TOWN OF MONUMENT 2.0 MG WATER STORAGE TANK

MONUMENT COLORADO

90% SUBMITTAL

Site Development Plan _V2 combined redlines.pdf Markup Summary 1-27-2022

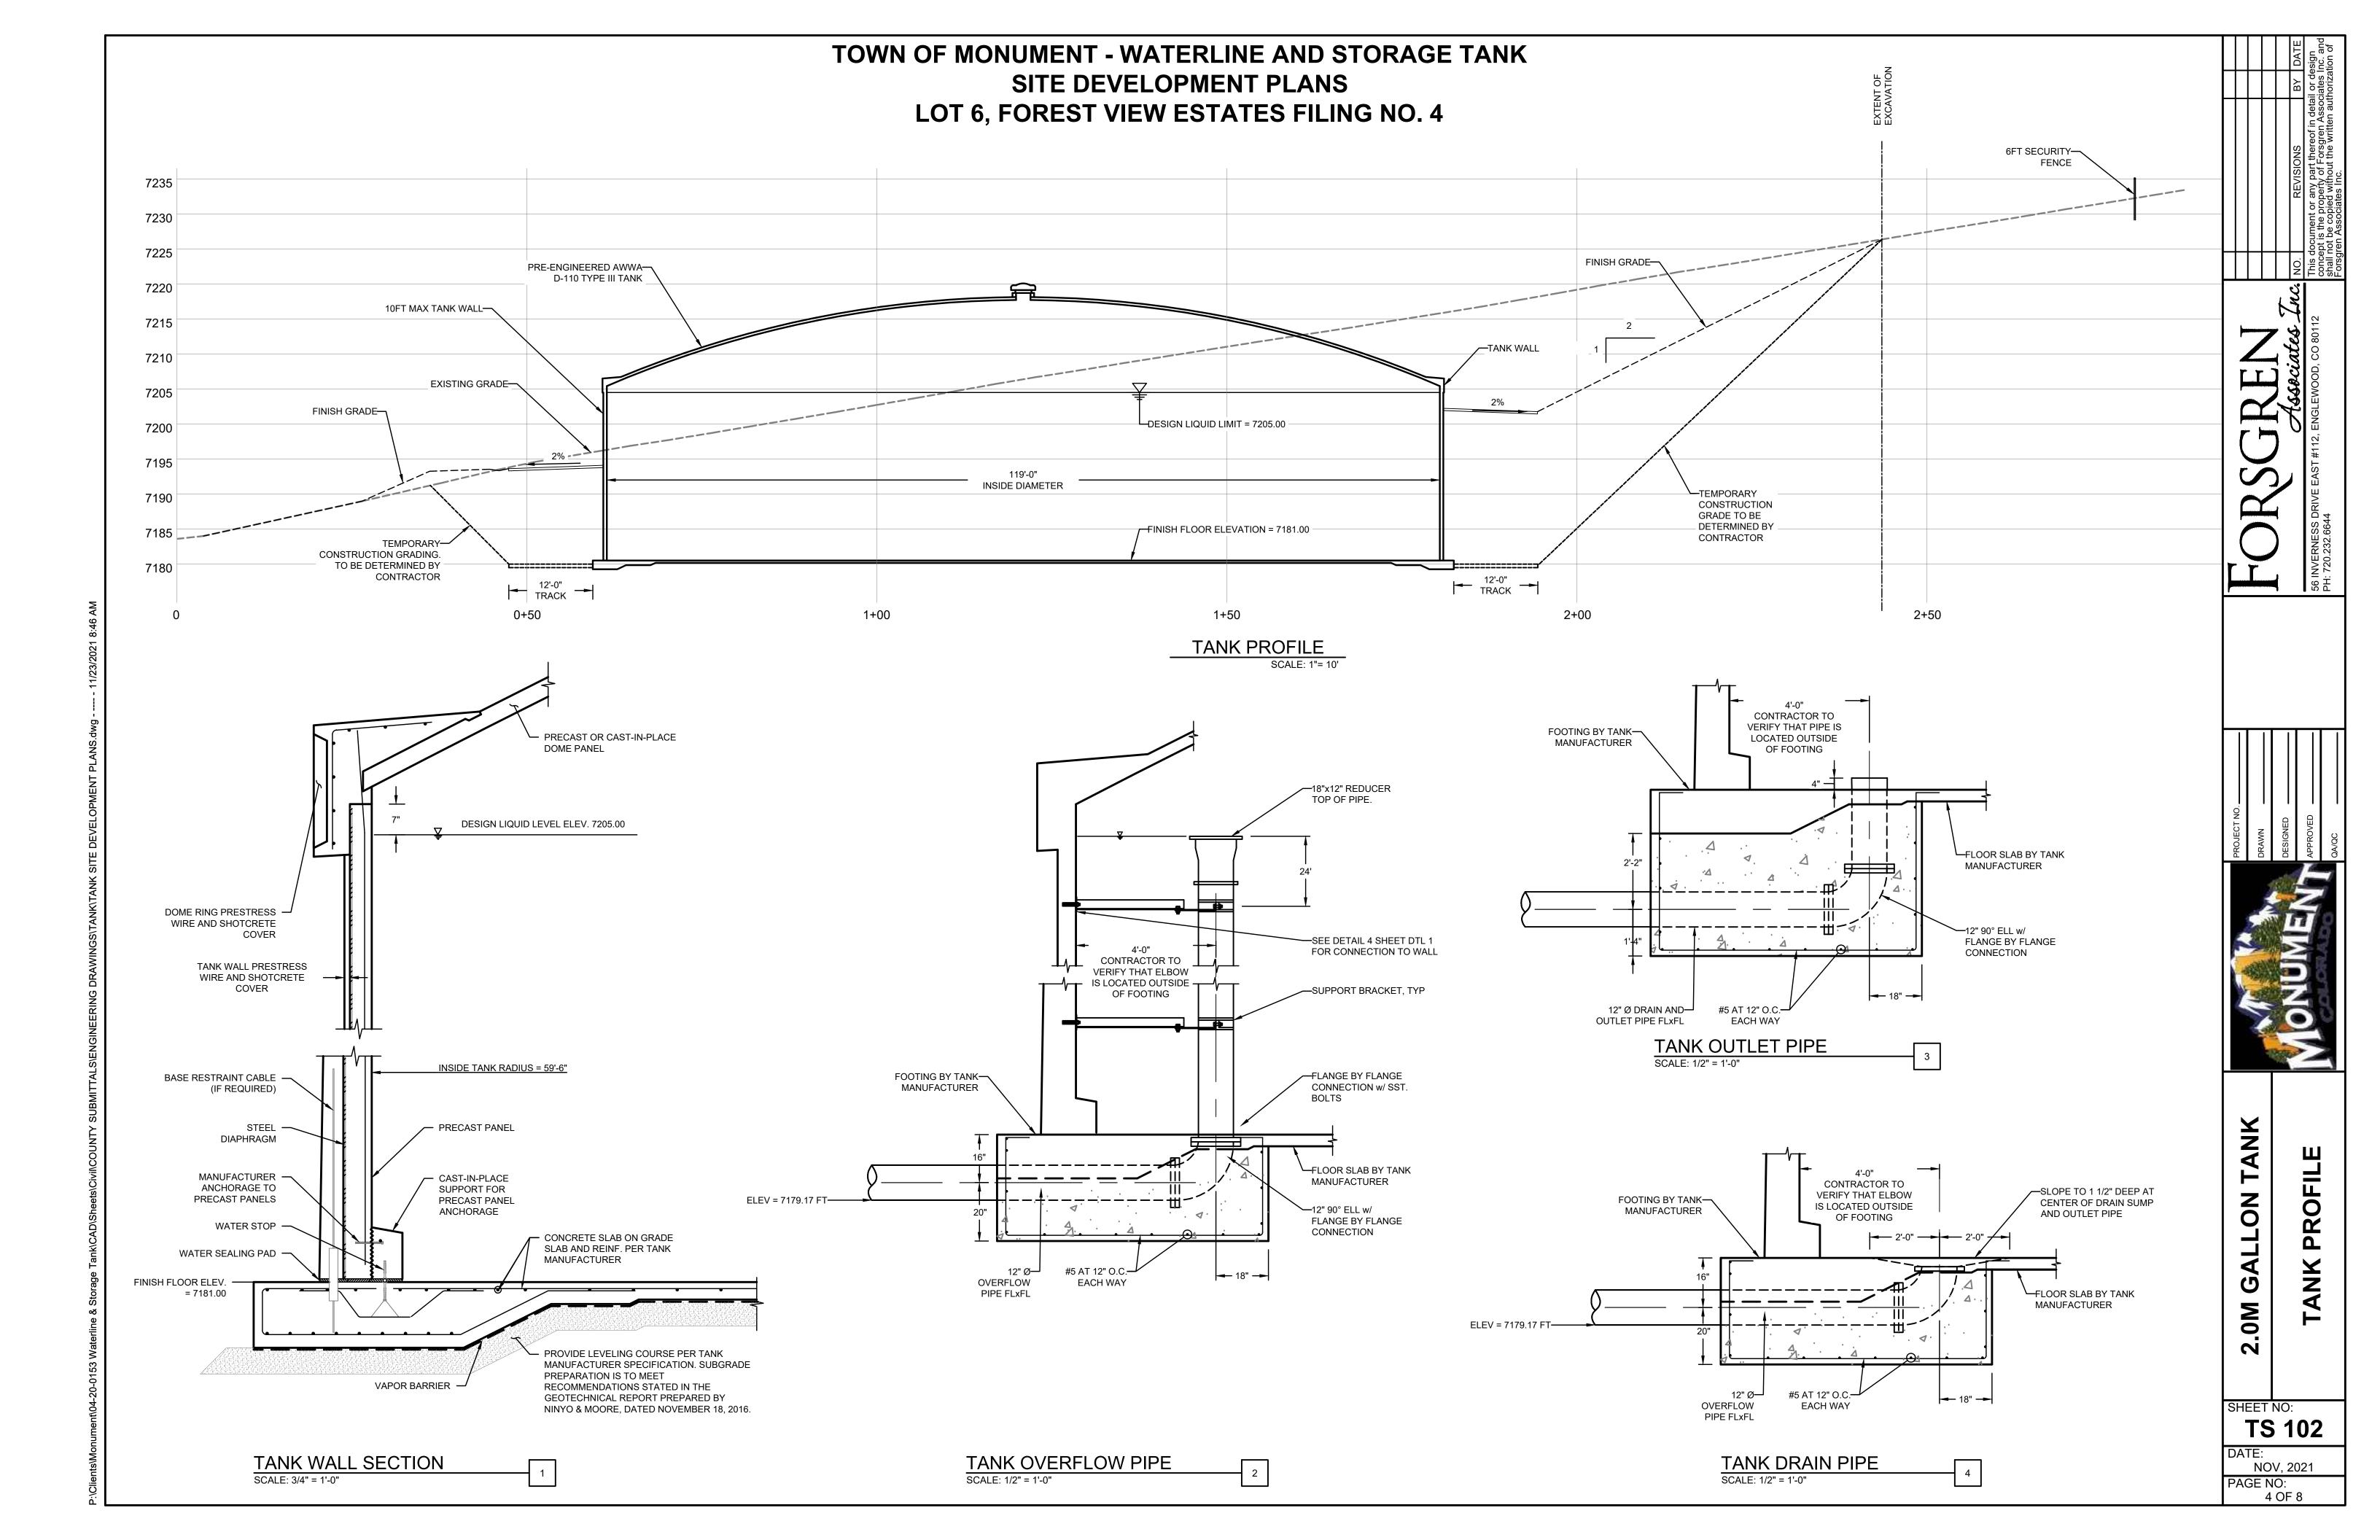
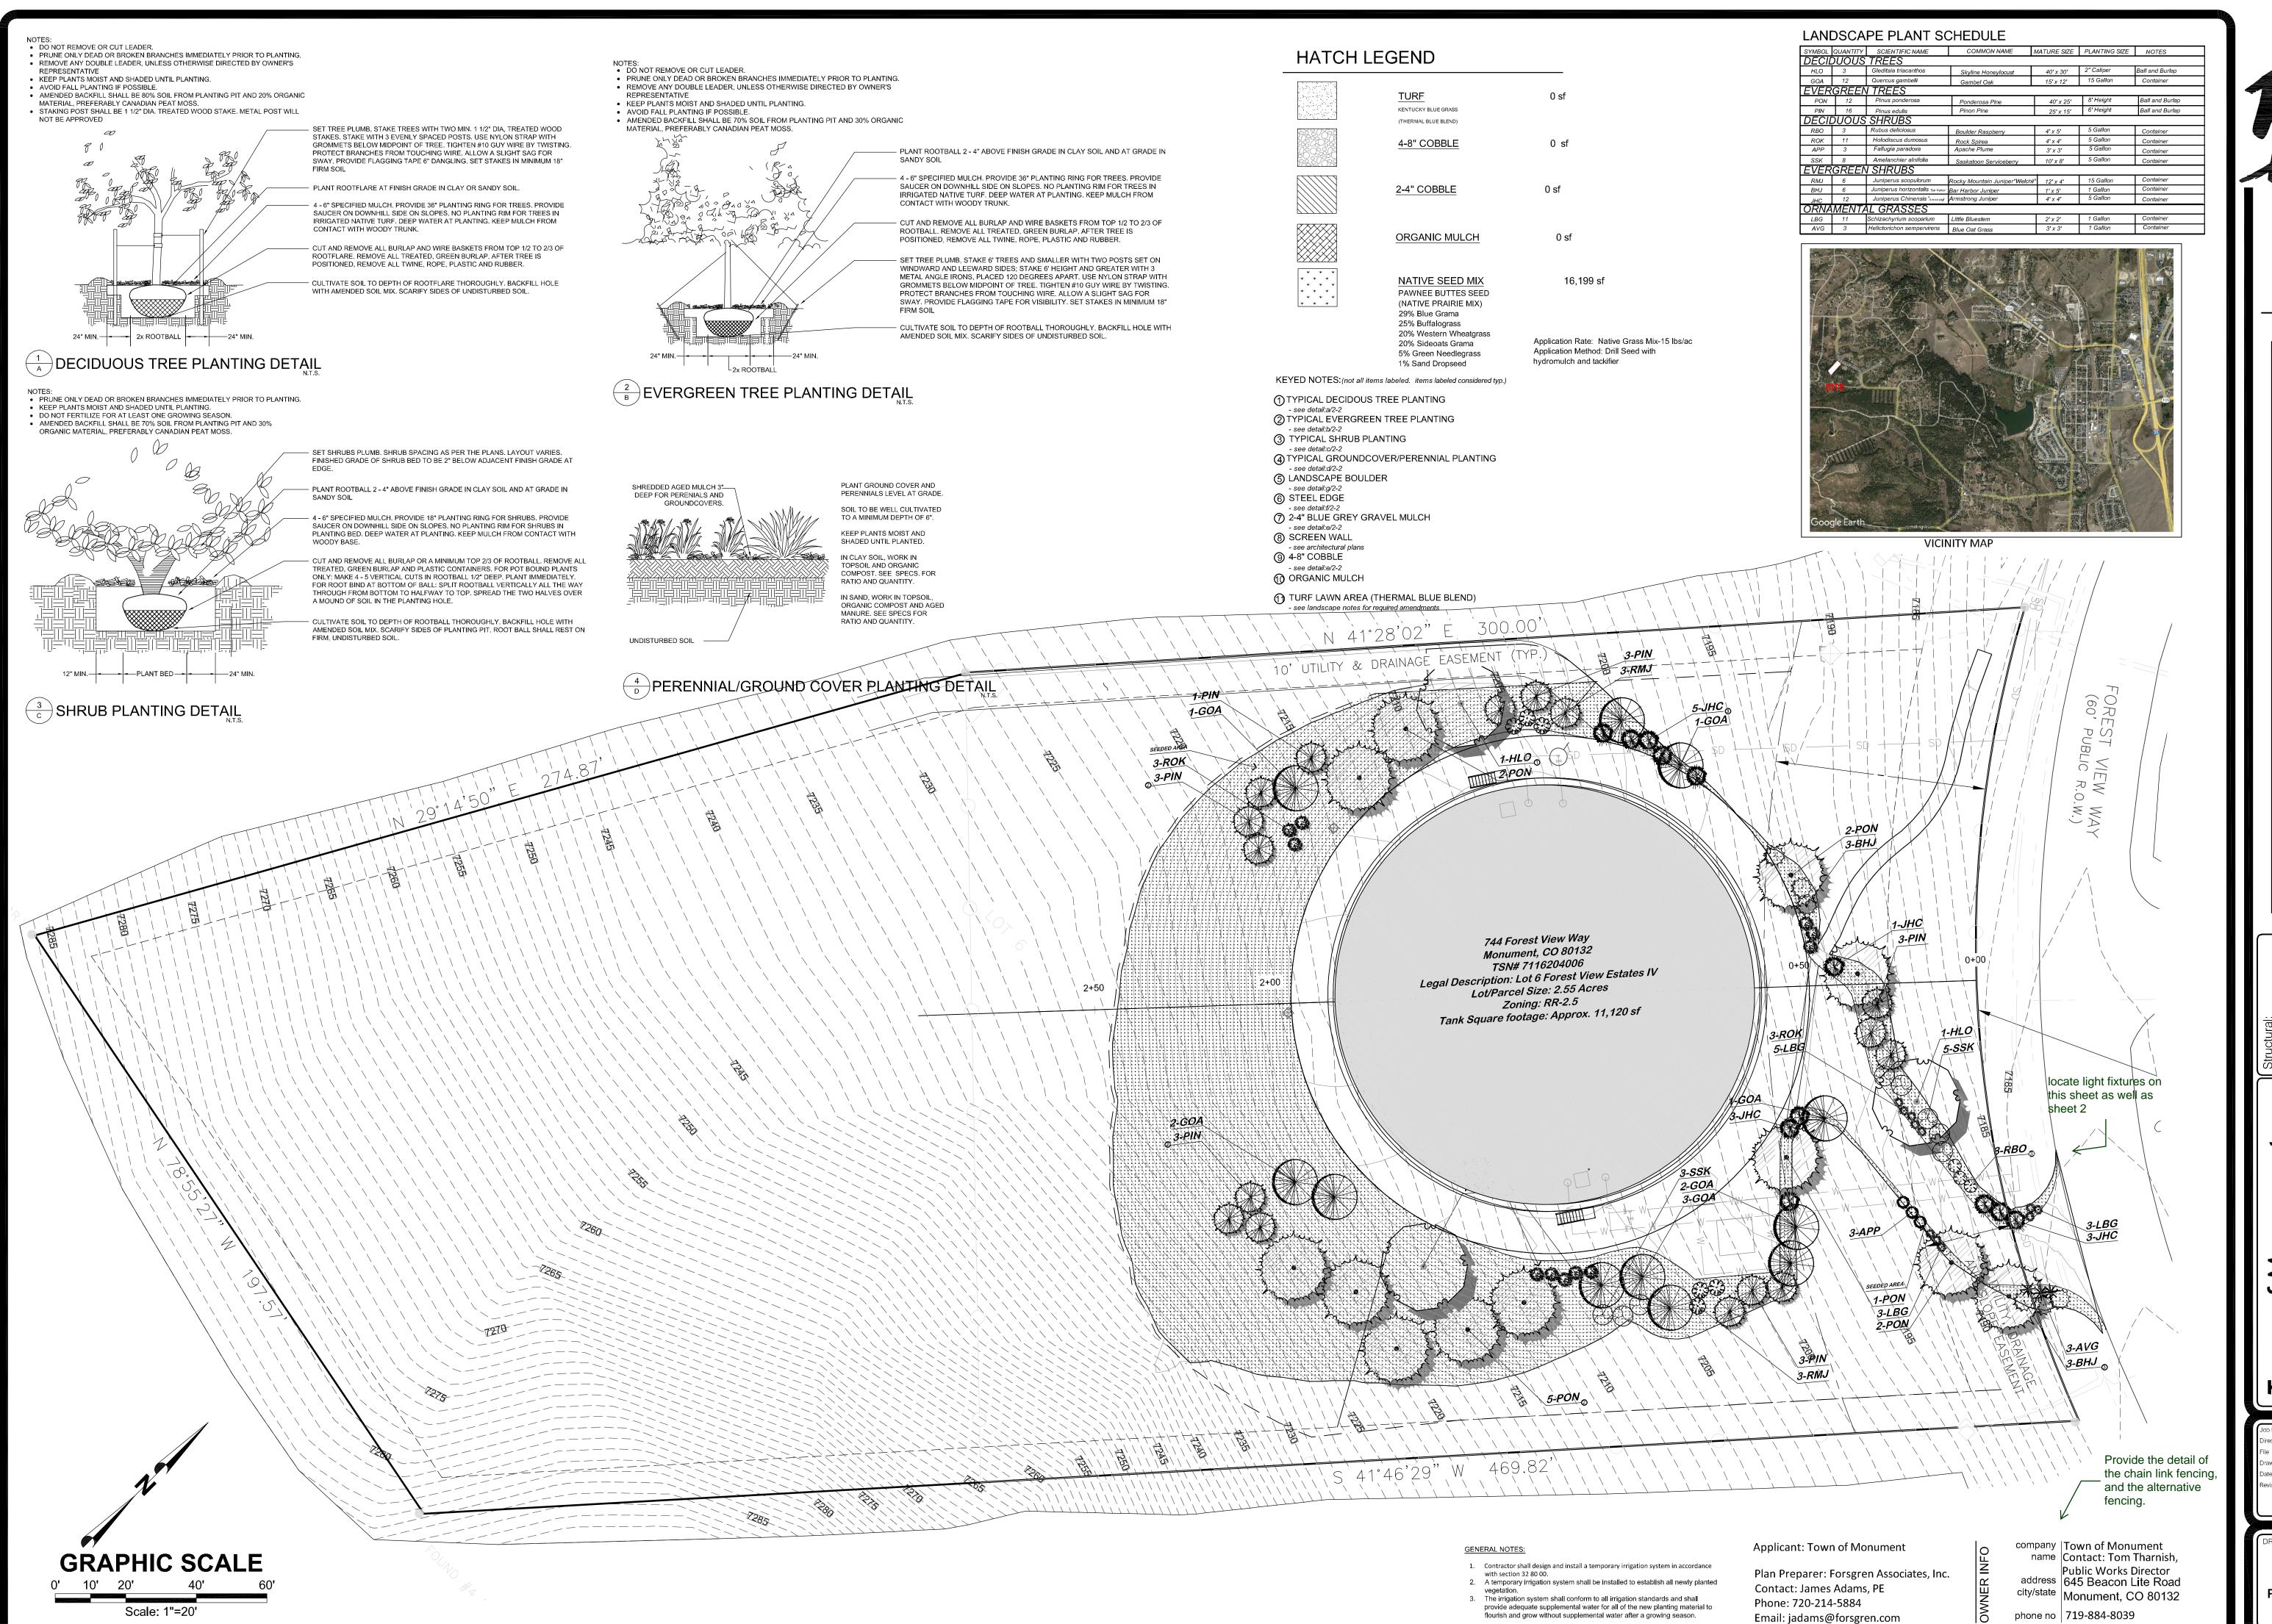
Add dimensions of chlorine bldg and future landing ...

Status: Color: ■ Layer: Space: Add circumference and total gallon storage

Status: Color: ■ Layer: Space: delete this from al;I pages- this is for a

construction approval

Status: Color: Layer: Space: HDPE plastic is not allowed for open ditch driveway culverts.

Status: Color: Layer: Space: Please copy these grading notes to the grading and erosion control plan. FYI: Information relating to construction and grading that needs to be approved by the manager needs to be in either the GEC or CDs.

o No. 20.028
ectory Landscape
LANDSCAPING PLAN 10-7-20
awn By DBN
de 8.23.2021
vised

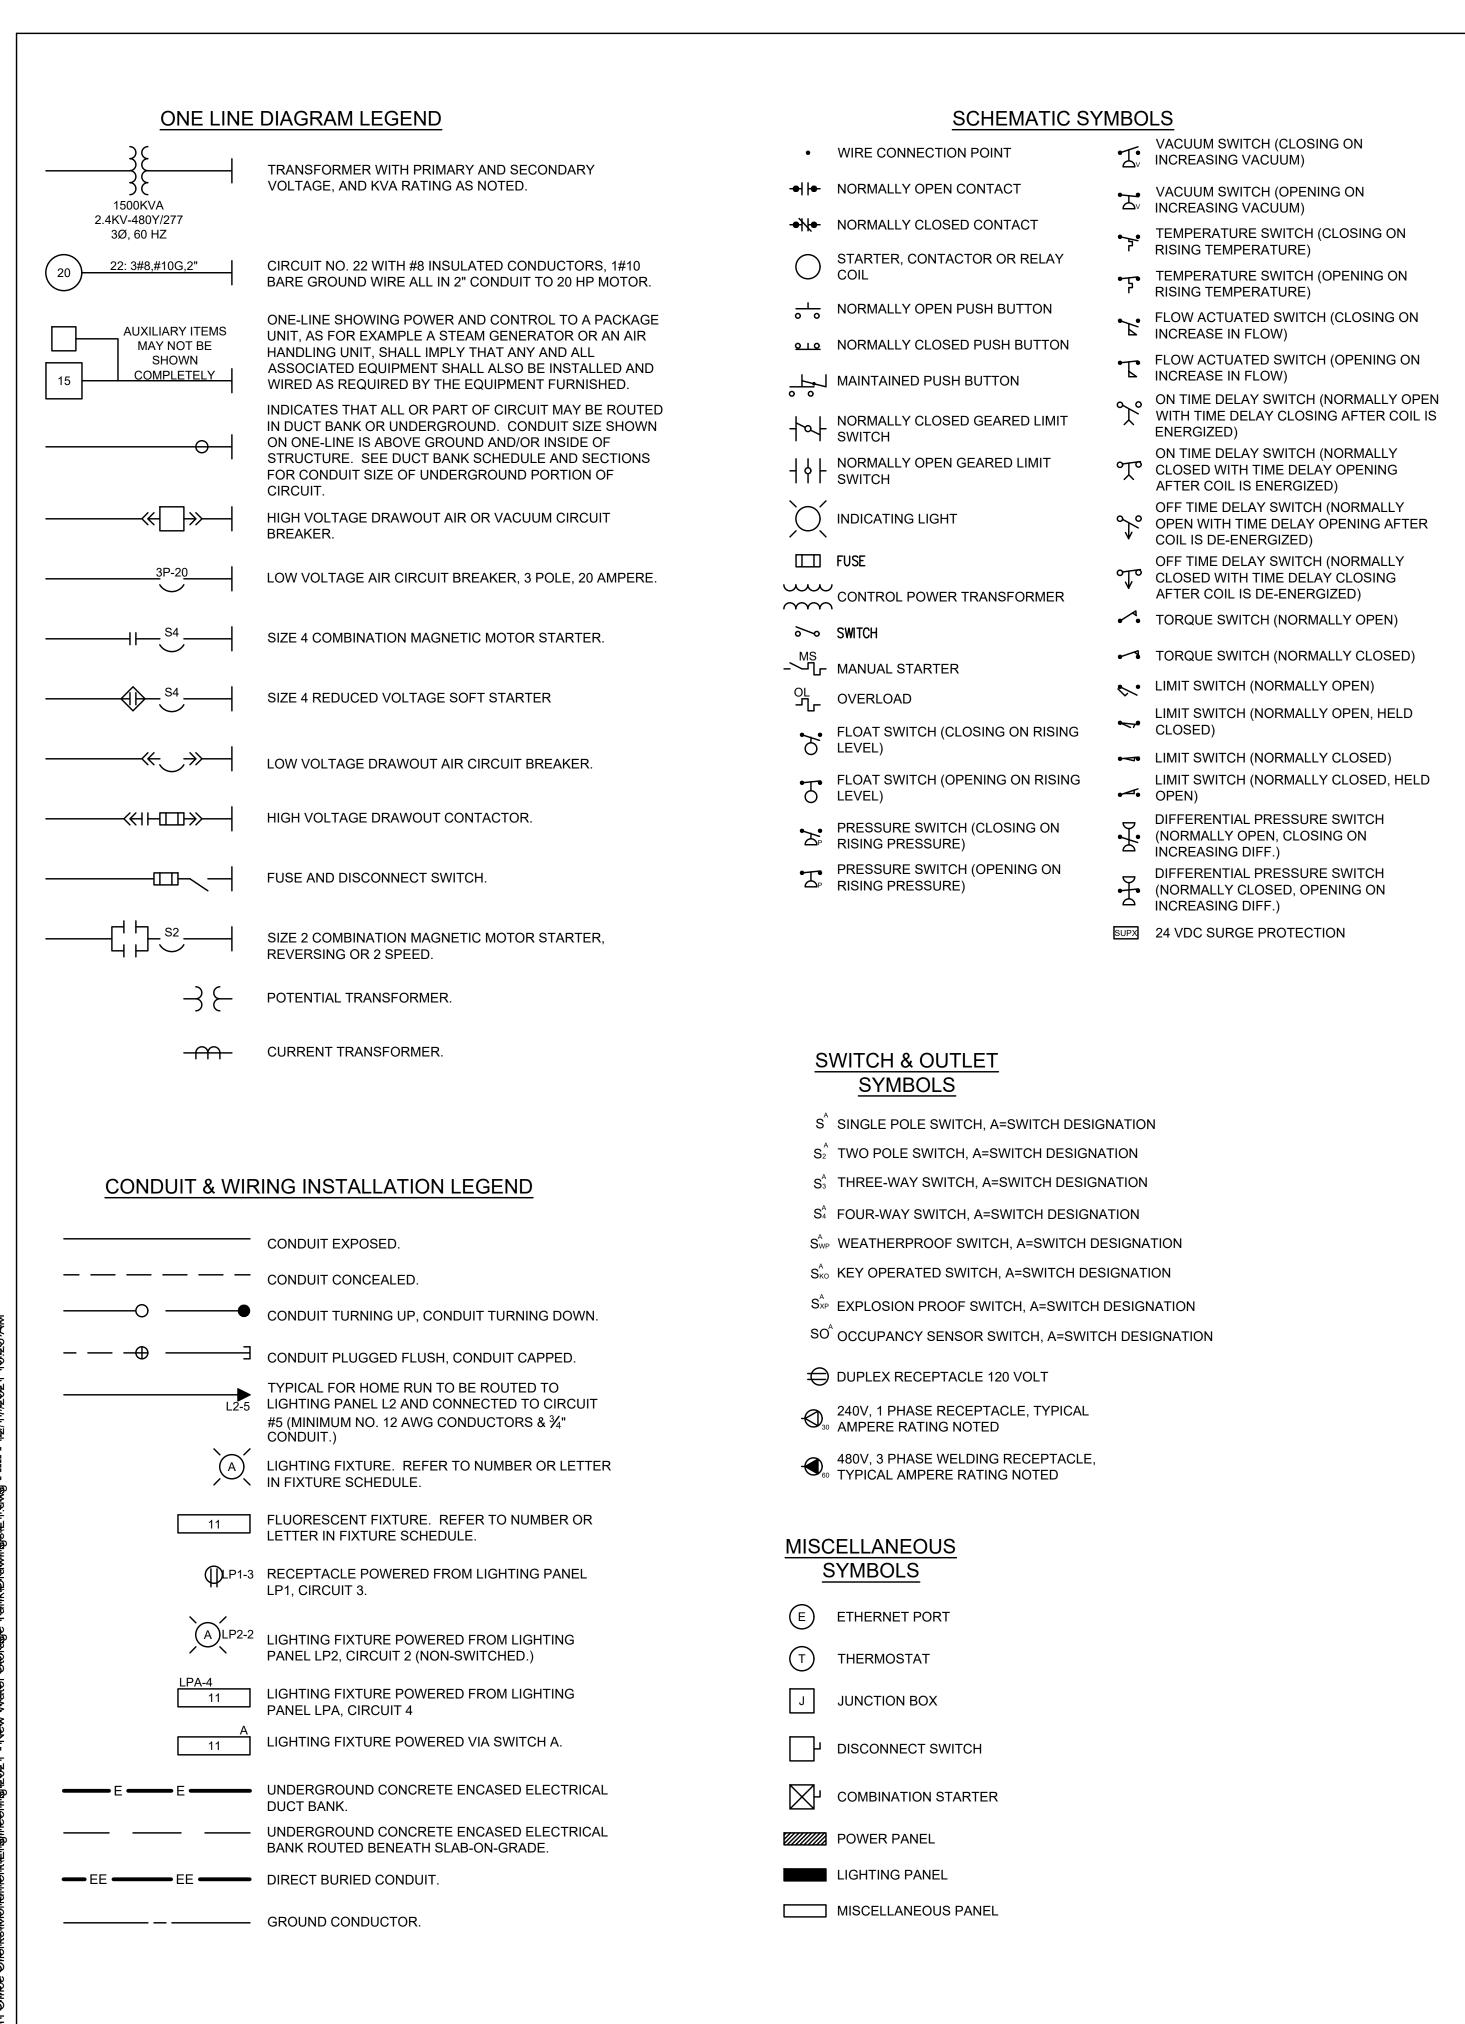
Status: Color: ■ Layer: Space: locate light fixtures on this sheet as well as sheet 2

Status: Color: ■ Layer: Space: Provide the detail of the chain link fencing, and the alternative fencing.
